SERVICE BULLETIN

ENGINE - ACTUATING MECHANISM HP COMPRESSOR VARIABLE VANES - INTRODUCTION OF STAGE-4 AND 5 VSV BRIDGE-PIECE ASSEMBLIES WITH REVISED METHOD OF MANUFACTURE

EC98VR012

V2500-ENG-72-0348

Figure 1 - Sheet 2
View of section AD - Before and after alteration

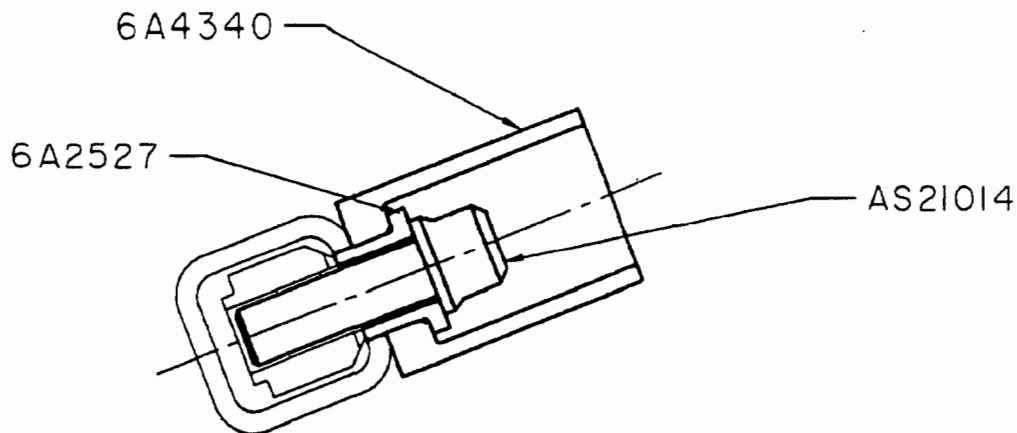
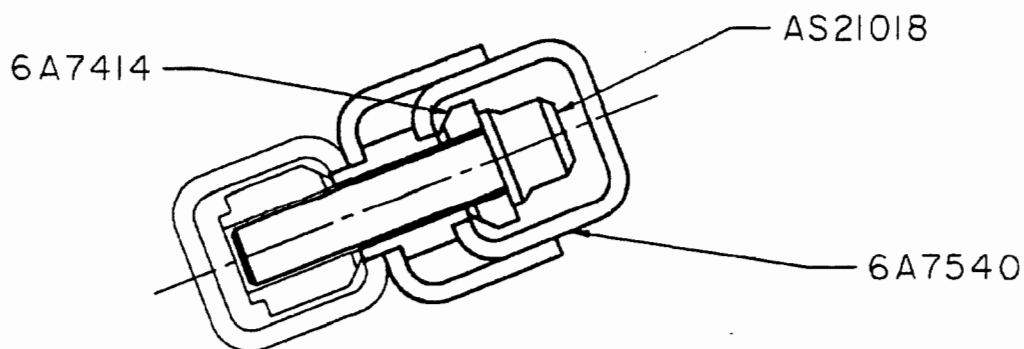
- (a) The central section of the bridge assembly is extended to overlap the ends of the unison rings.
- (b) The two machined end pieces are replaced by U-Section channels which are fillet welded to the central section.
- (c) To position the bridge-piece assembly radially and to provide spigot location on the unison rings, four integral spacers are introduced.
- (d) To attach the bridge-piece to the unison ring, a revised bolt with an increase in length is introduced on each stage.
- (e) The dowel under the bolt head is deleted.
- (f) An additional washer is introduced between the bolt head and the spacer.

SECTION AD
TYP.4 POS MARKED AE
PRIOR TO ALTERATION

SECTION AD
TYP.4 POS MARKED AE
AFTER ALTERATION

Figure 2 - Sheet 2
View of section AB - Before and after alteration

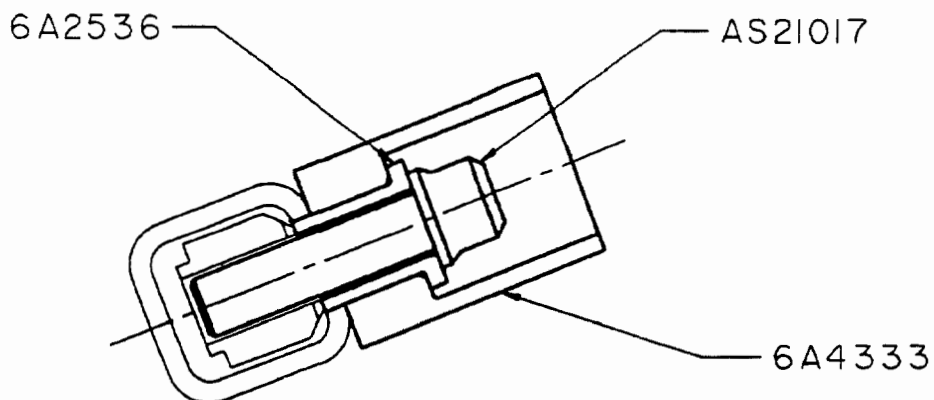
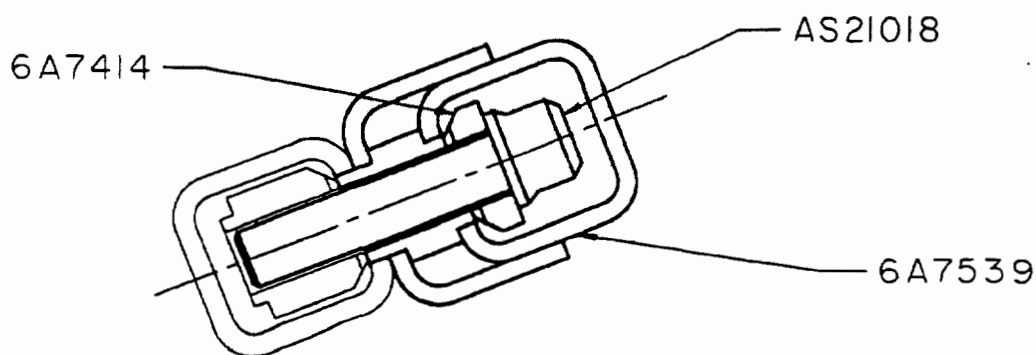
SECTION AB
TYP.4 POS MARKED AC
PRIOR TO ALTERATION

SECTION AB
TYP.4 POS MARKED AC
AFTER ALTERATION
